STATE OF HAWAII
 DEPARTMENT OF TRANSPORTATION
 HIGHWAYS DIVISION
SITE PLAN - 1
SITE 5 - MP 27.7
 EMERGENCY EARTHQUAKE ROCKFALL REPAIRS
 VARIOUS LOCATIONS ON HAWAII, UNIT 4
 Federal Aid Project No. ER-15(22)
 Scale: As Shown Date: December 2009
 SHEET No. G-5.1 OF 9 SHEETS

07/28/10	Added Note per Addendum 3
DATE	REVISION

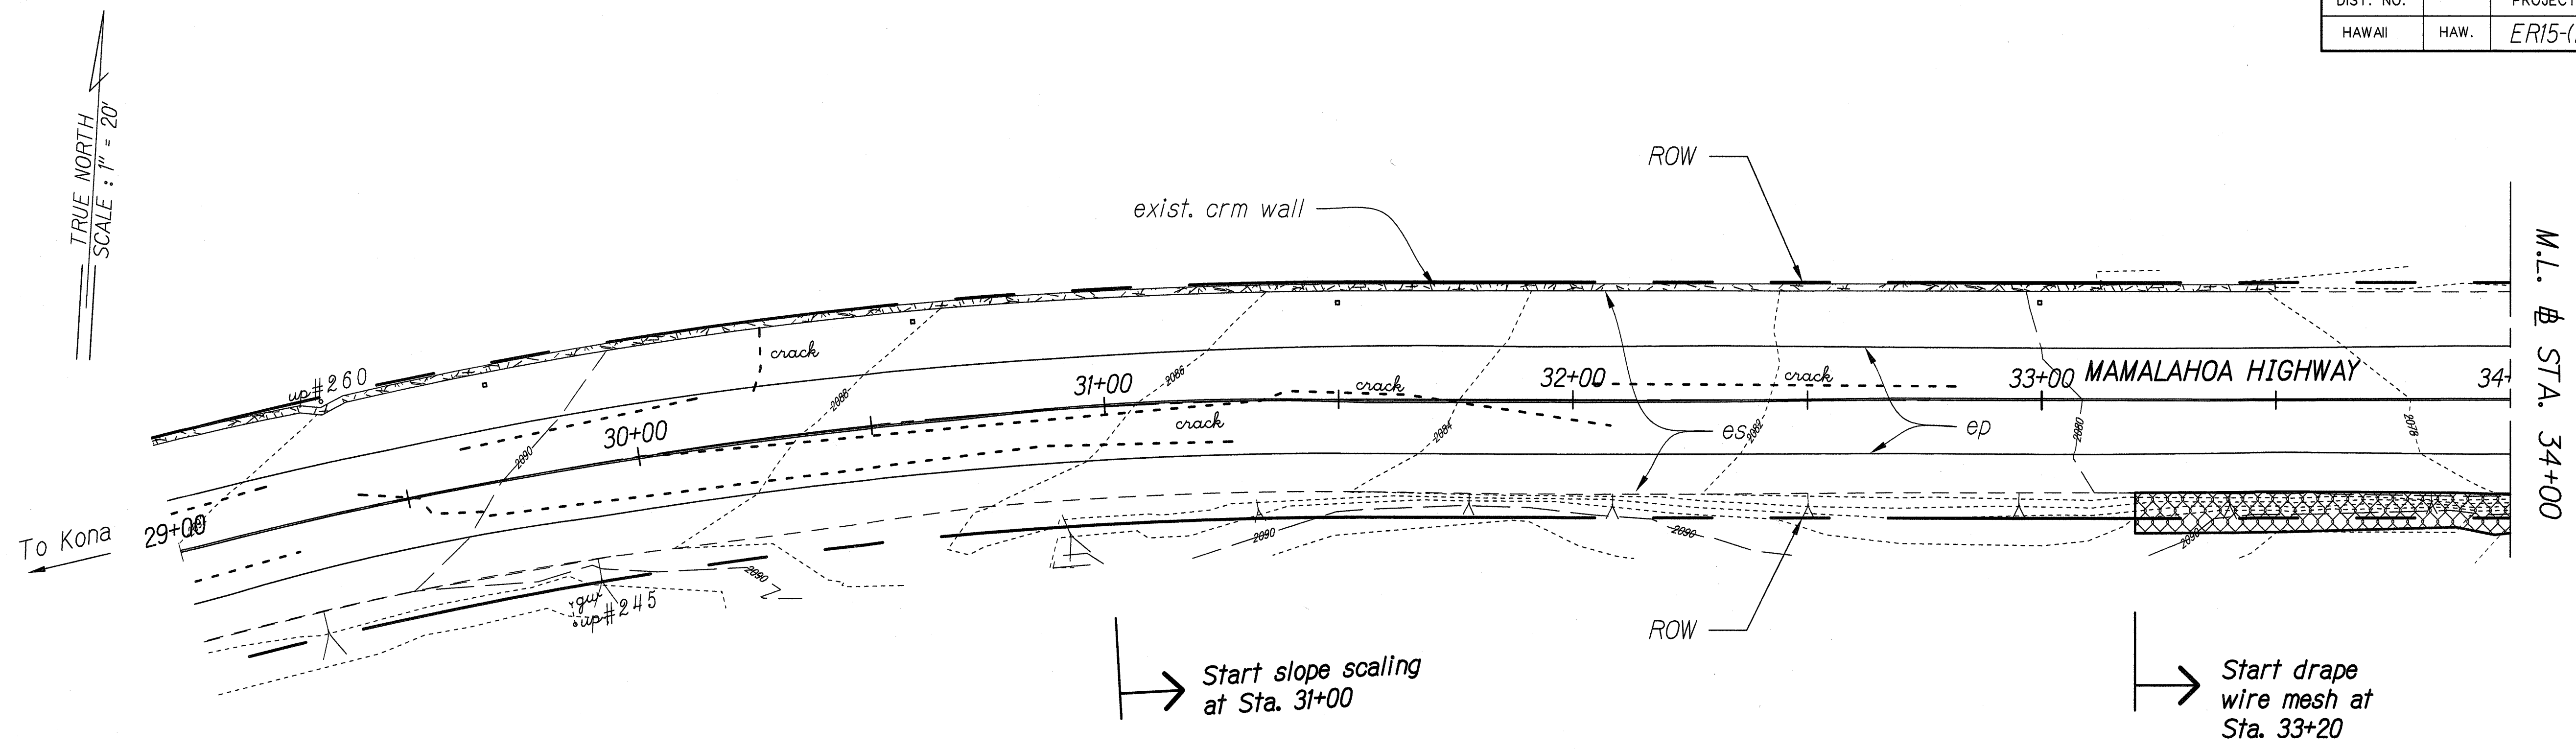
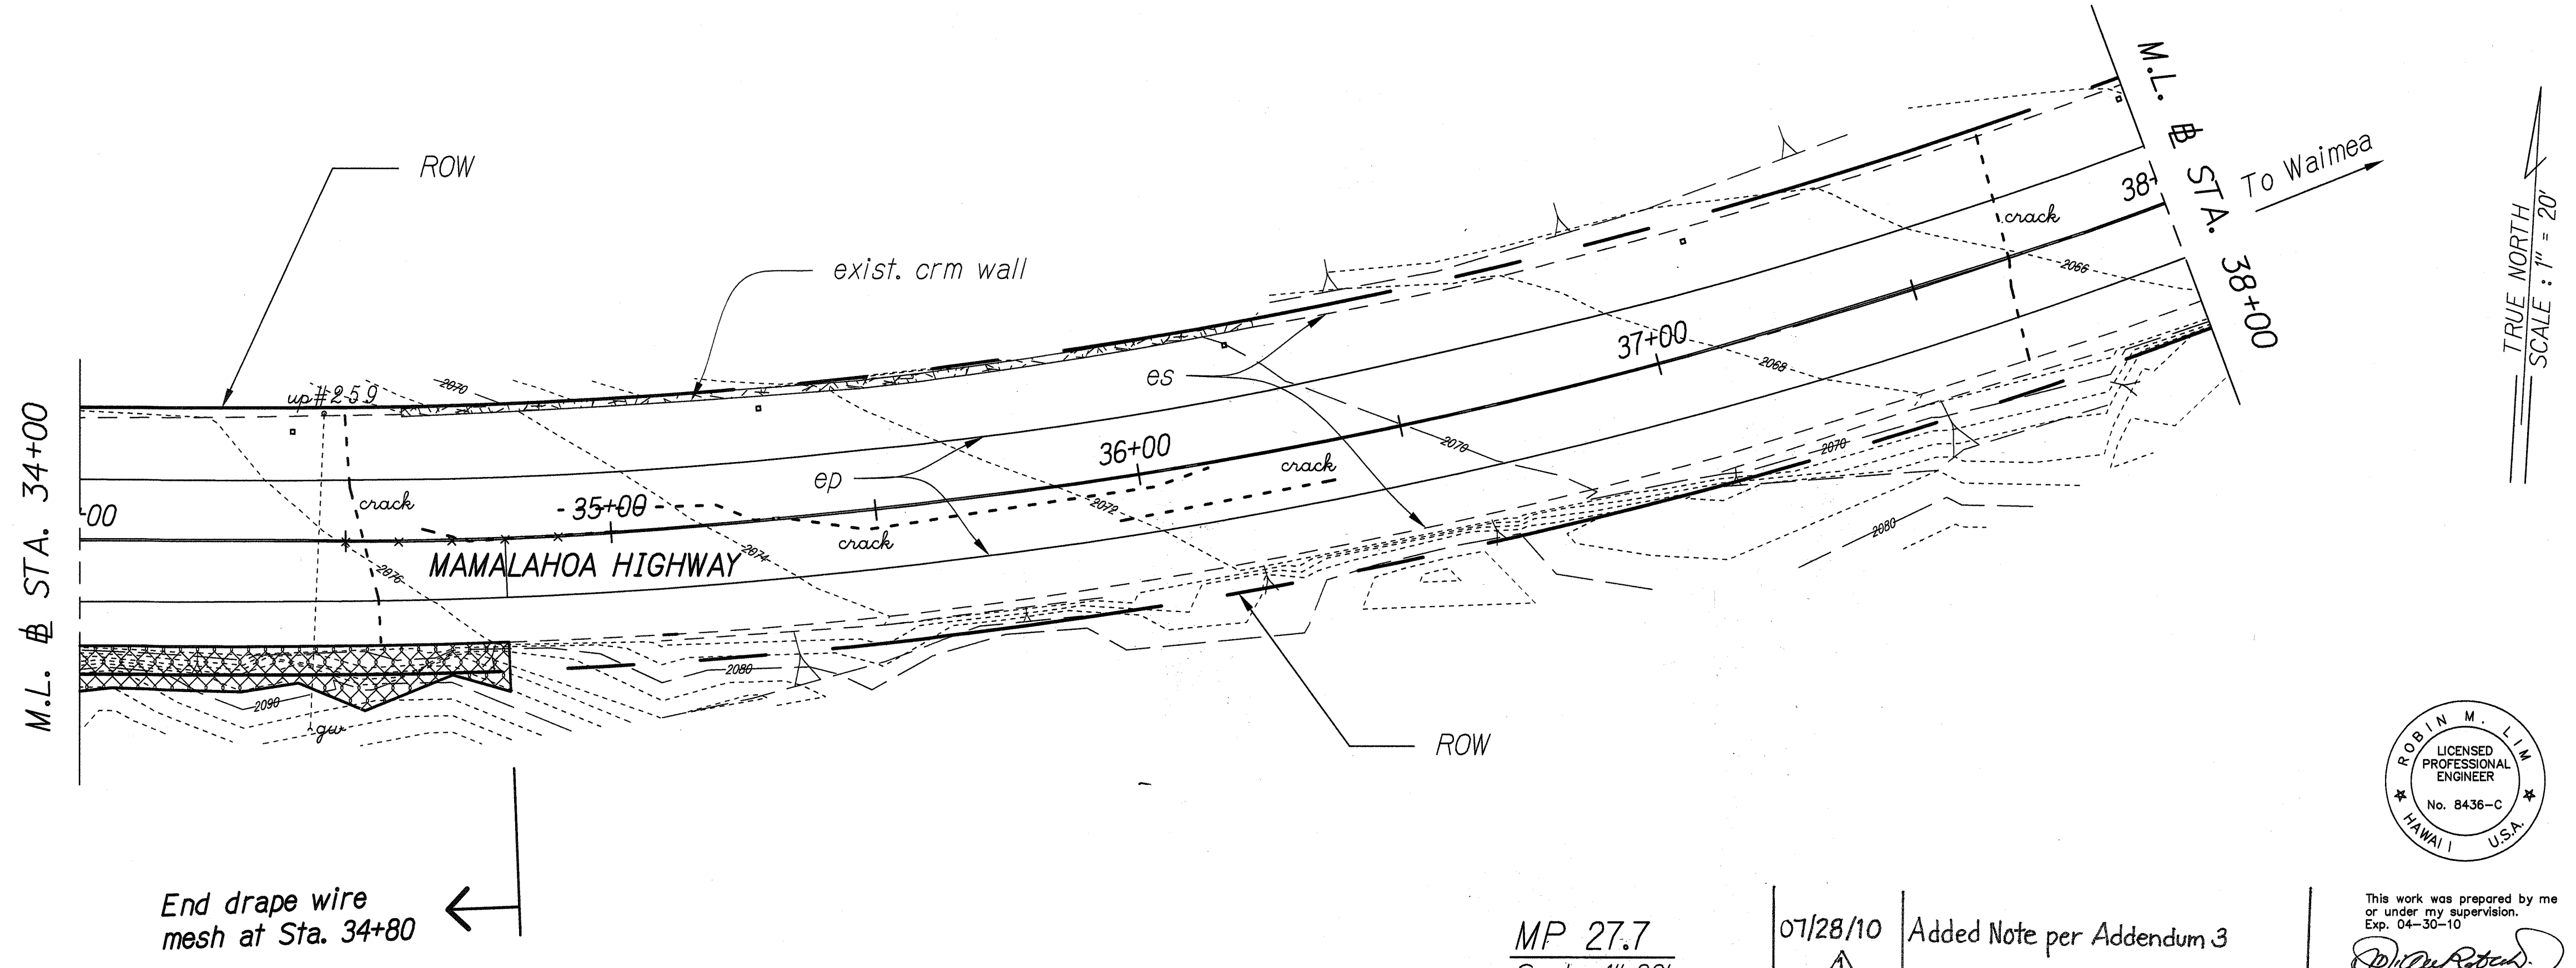
Note:
 Sta. 30+50 to 41+50 Rt.
 Remove and Replace Existing e.p. 4"
 White Stripe with Type "C" Markers
 at 40' o.c.

SHEET No. G-5.2 OF 9 SHEETS

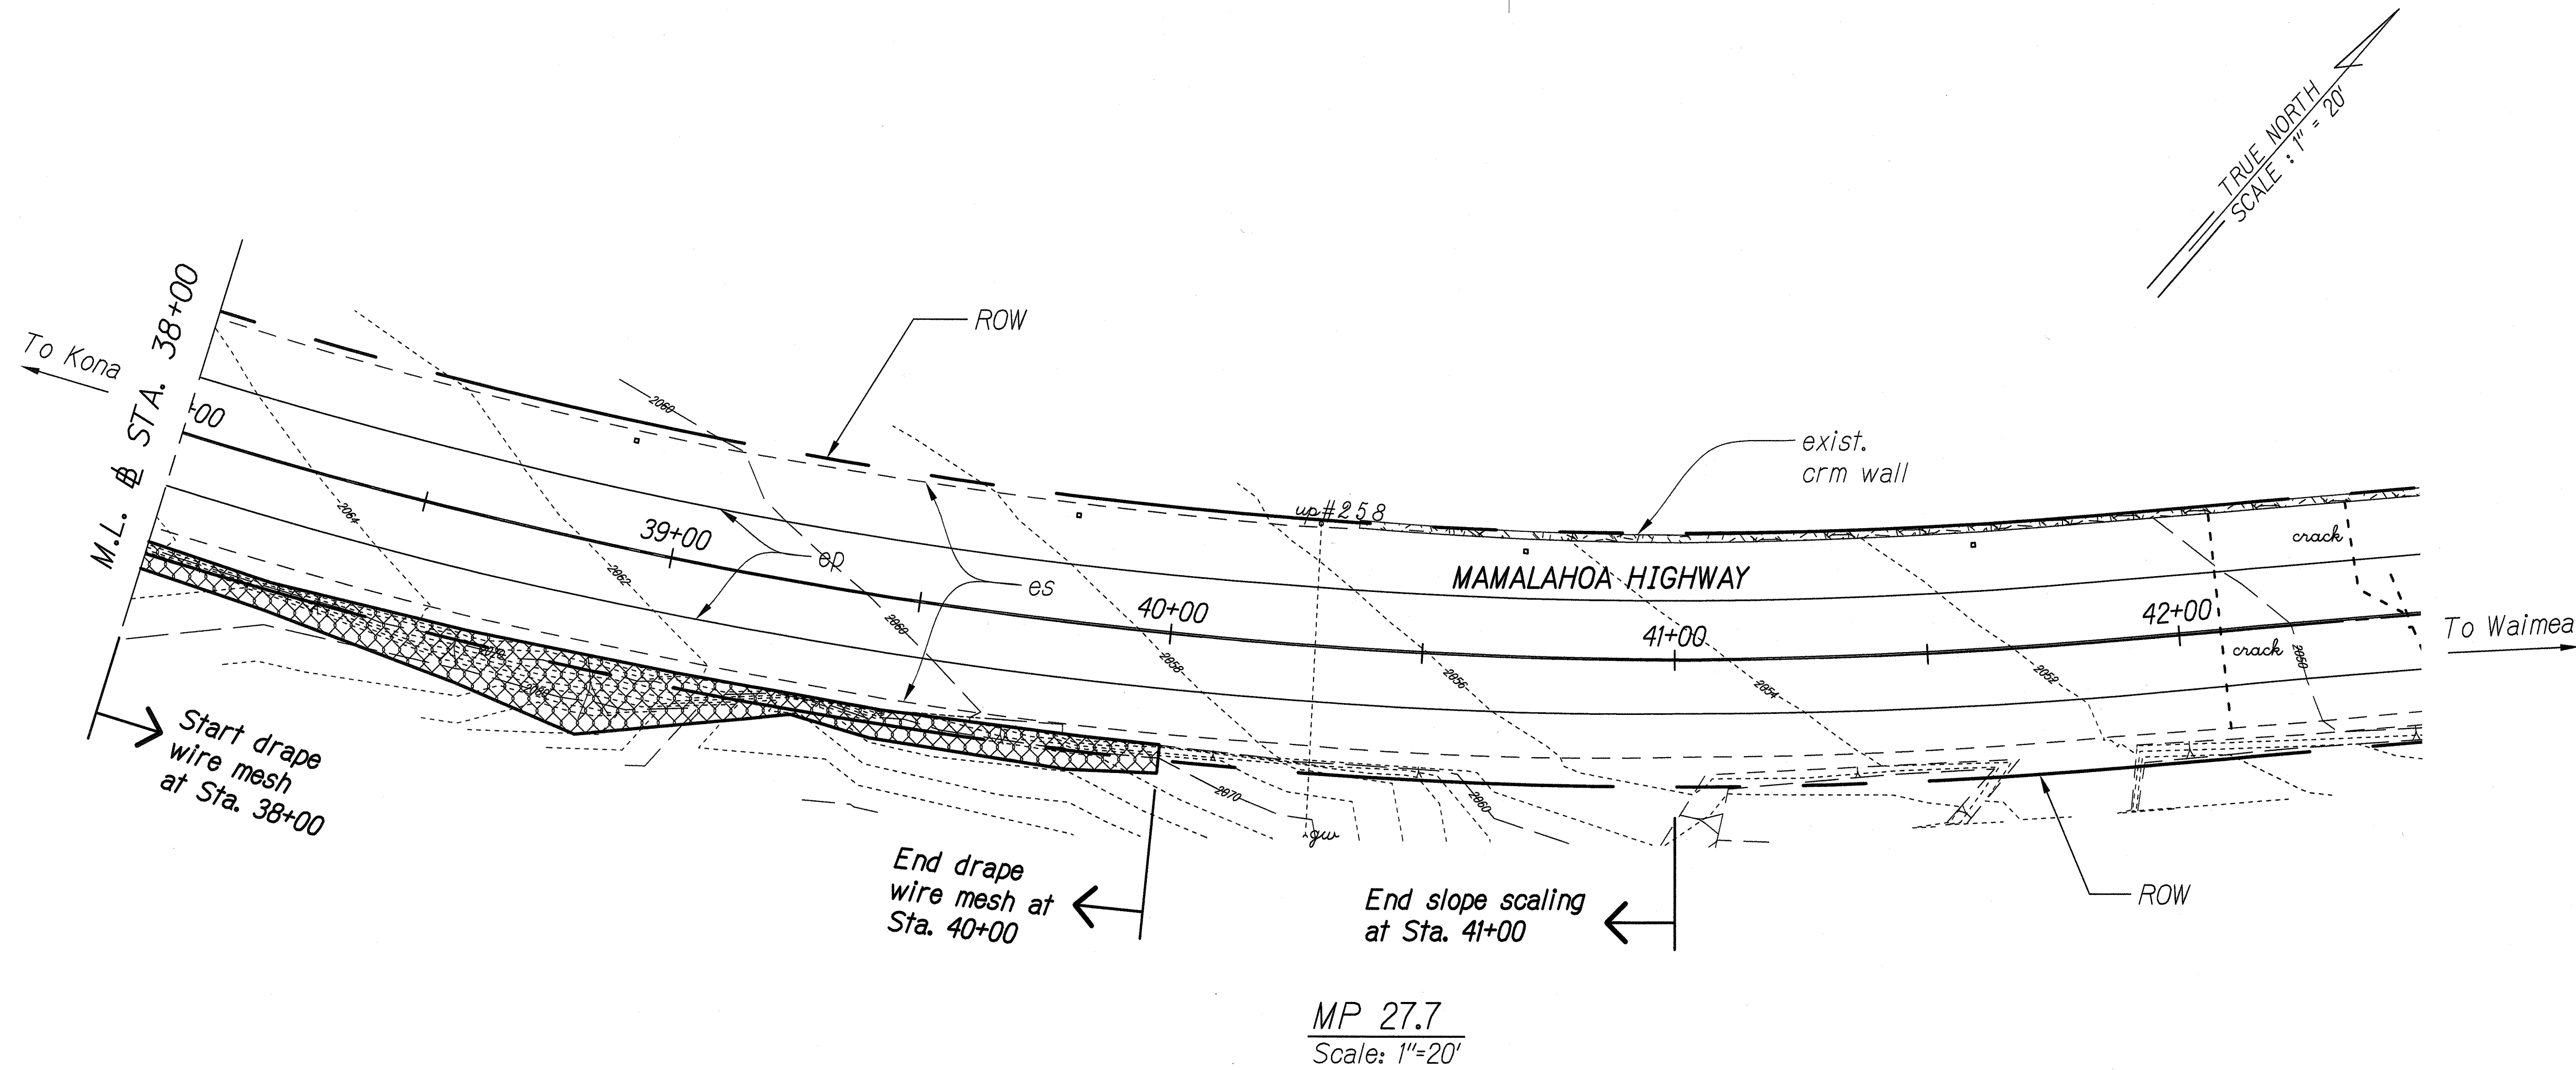
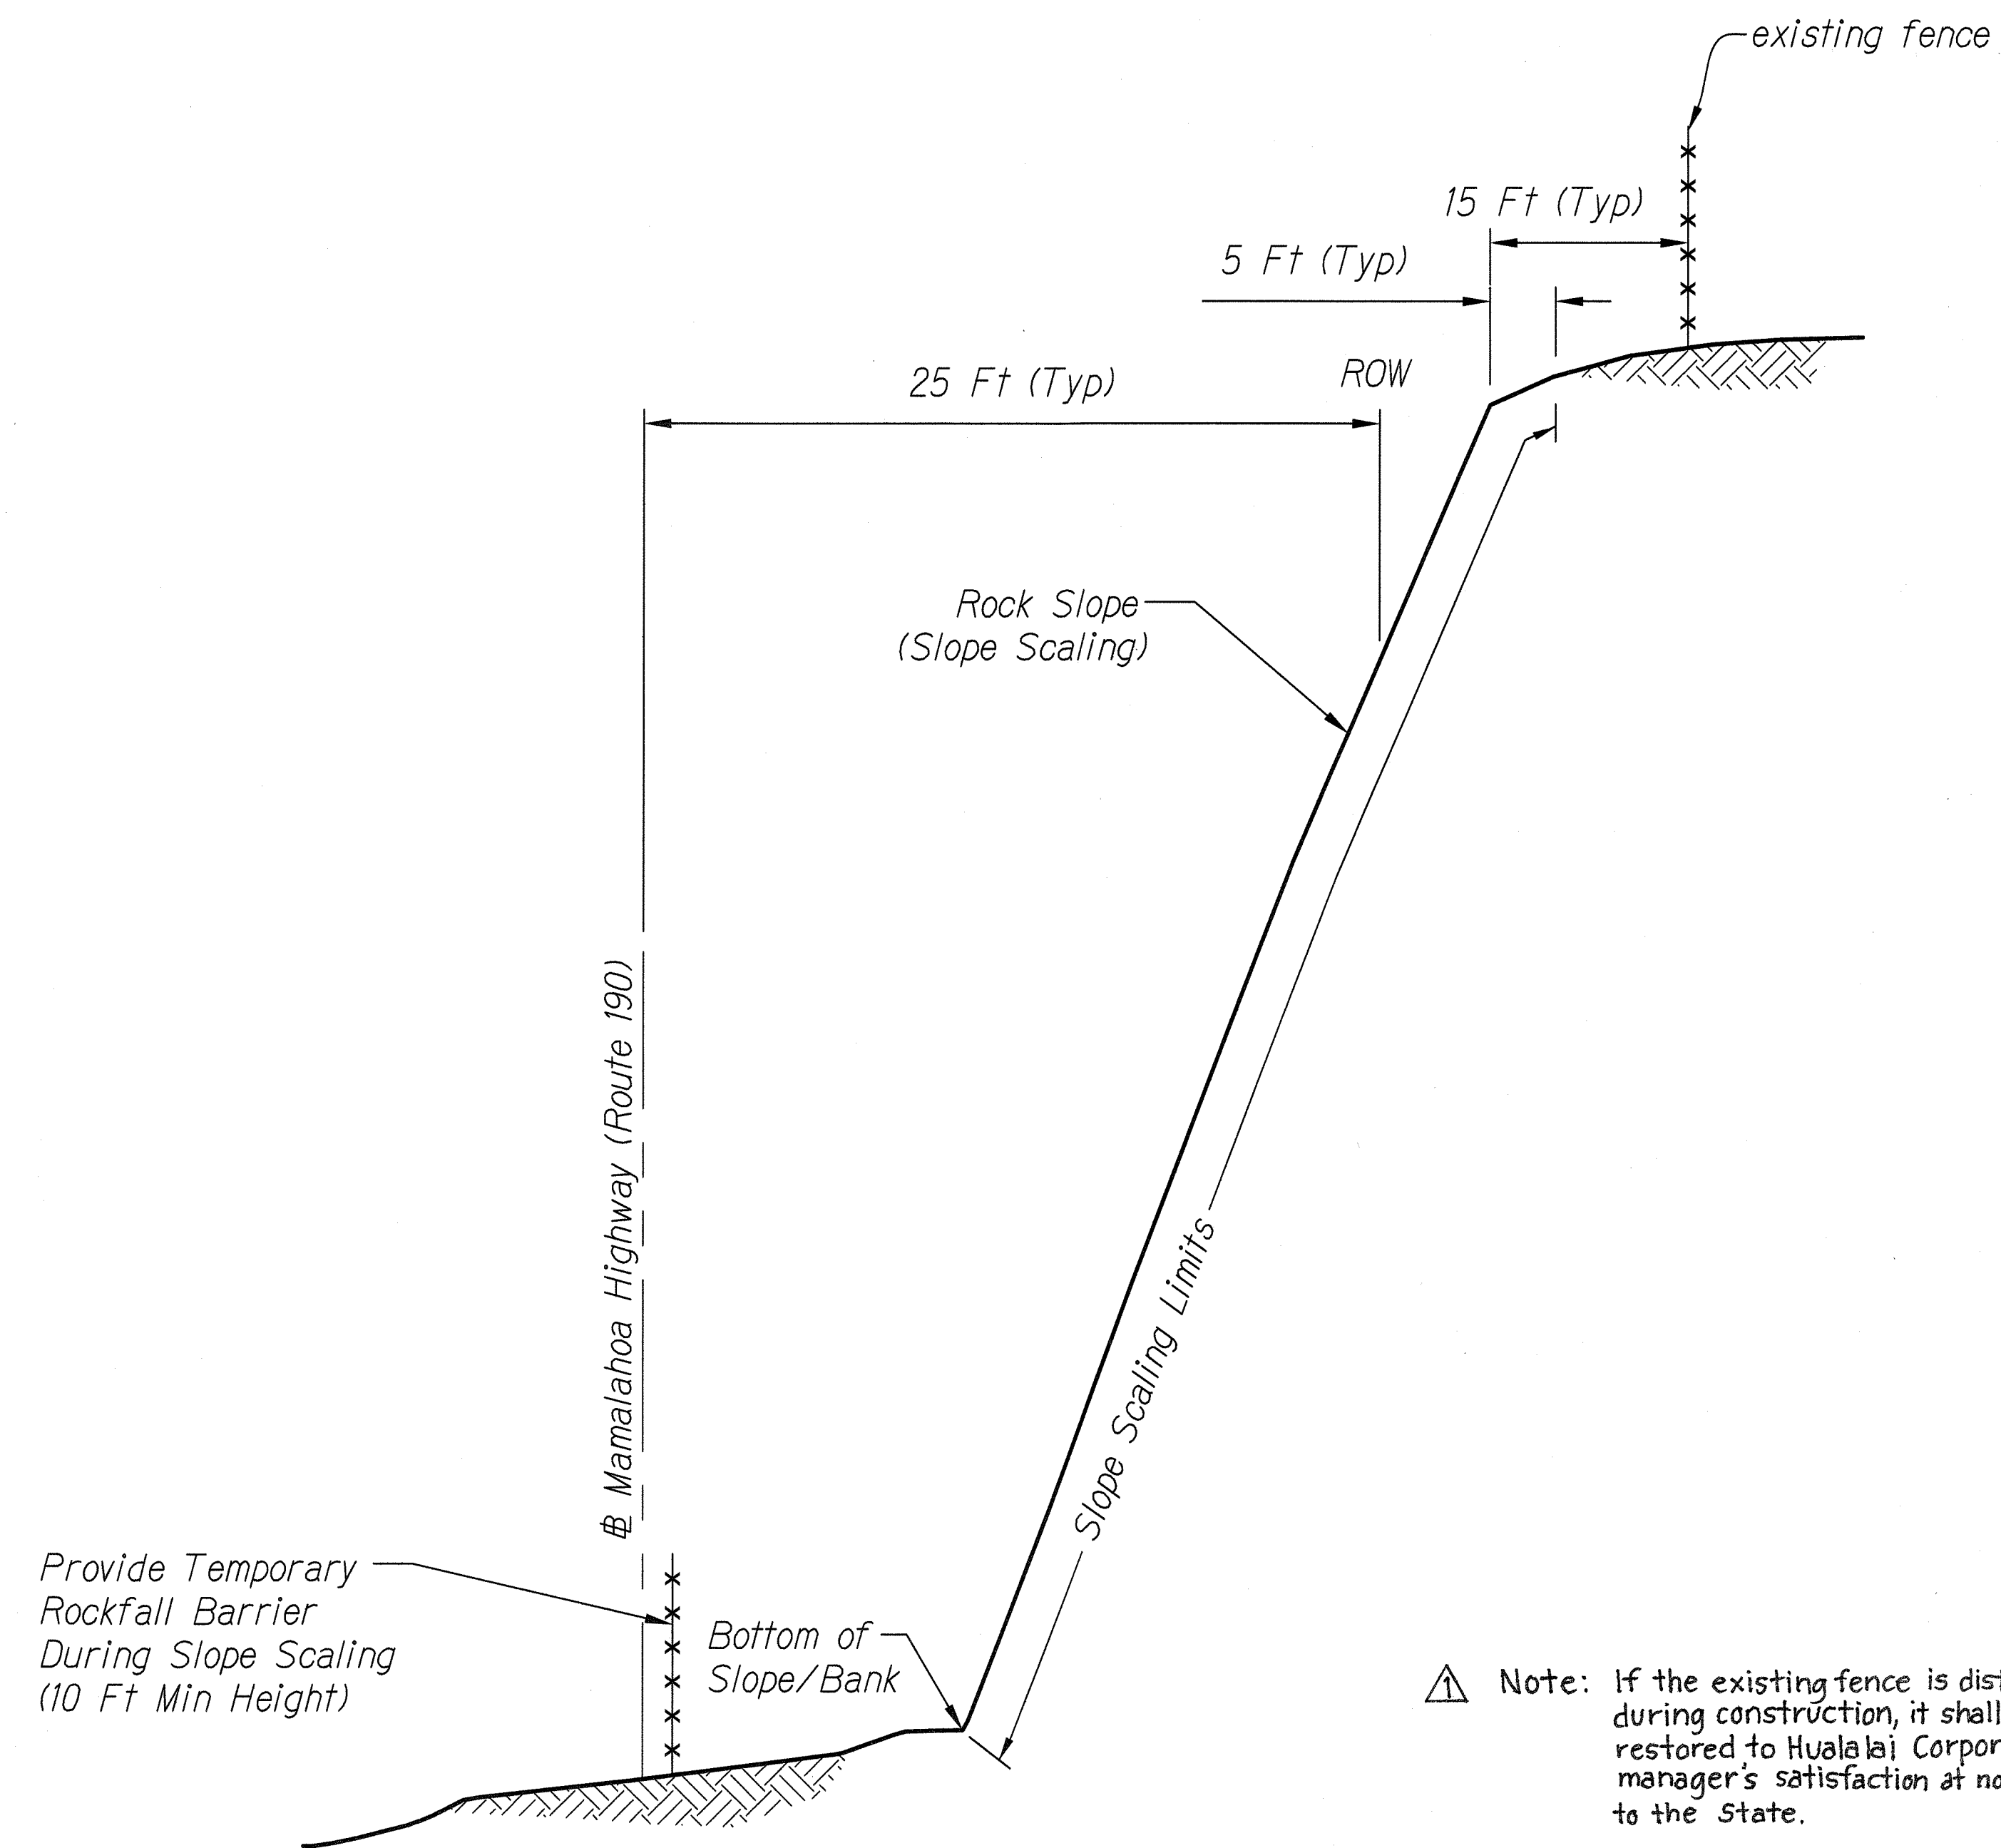
⚠ Note: Sta. 30+50 to 41+50 Rt.
Remove and Replace Existing e.p. 4"
White Stripe with Type "C"
Markers at 40' o.c.
